**Southern Sandoval
County
Arroyo Flood Control
Authority**

LOWER MONTOYAS ARROYO BANK
STABILIZATION PROJECT

LOW FLOW CONCRETE CHANNEL
DETAILS

CONCRETE LOW FLOW CHANNEL SECTION
BASE BID = NO CONCRETE COLOR

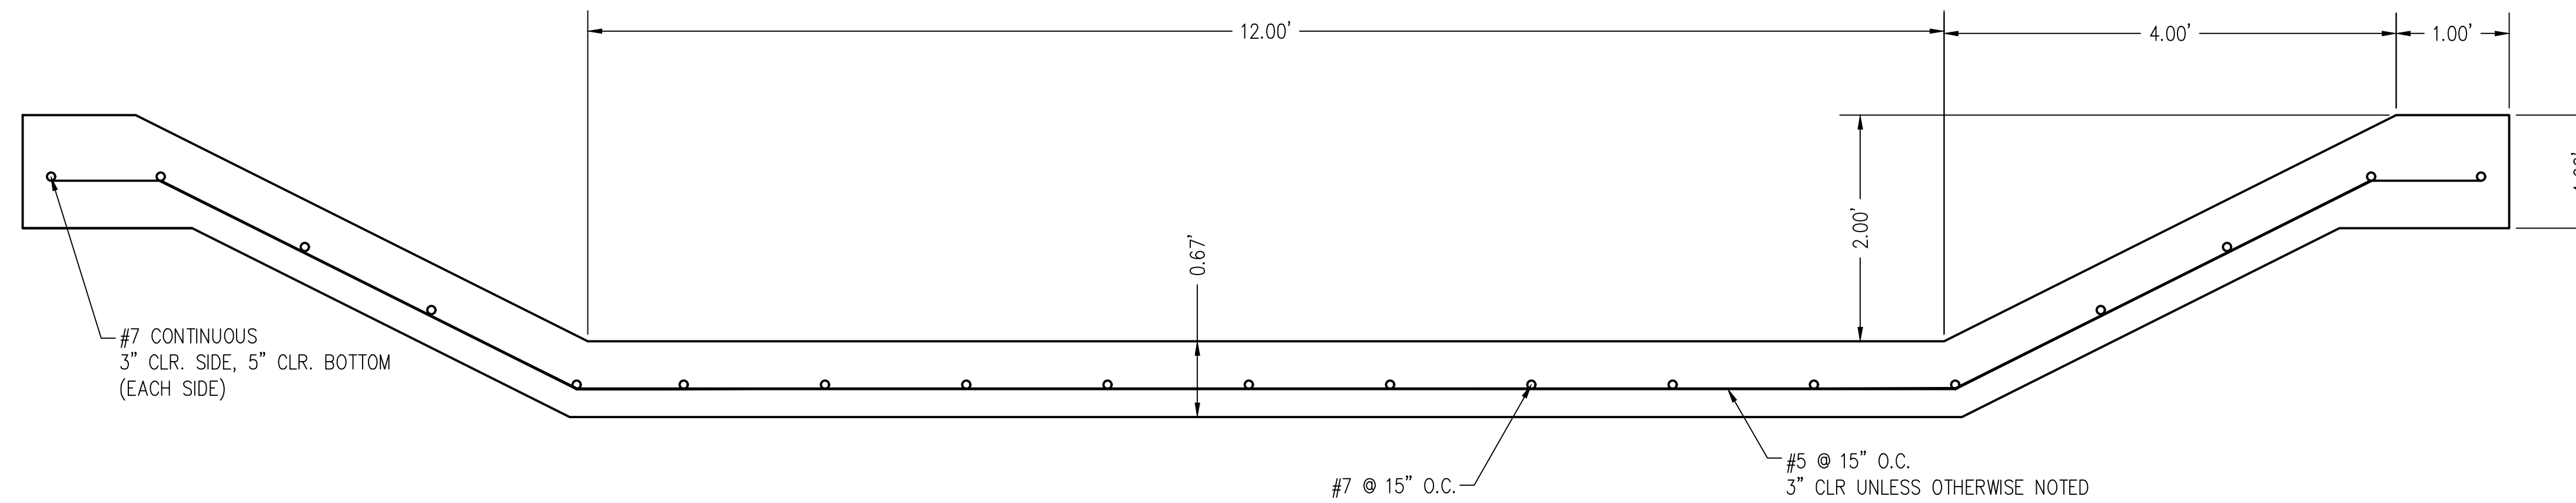
2 NOTES ADDED

1 REMOVAL OF ADDITIVE ALTERNATIVE #1
